Application. No. 10/072,592 Amendment dated March 15, 2004 Reply to Office Action of January 11, 2004

REMARKS/ARGUMENTS

Figure 4

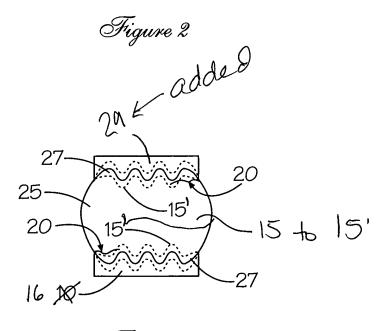
The drawing changes submitted with the Response filed on October 14, 2003 were objected to. A new FIGURE 4 submitted herewith is believed to overcome the objections to the drawings. In addition, reference number 29 on FIGURE 4 was not discussed in the specification. The amendment to the specification presented in this response is believed to overcome this objection.
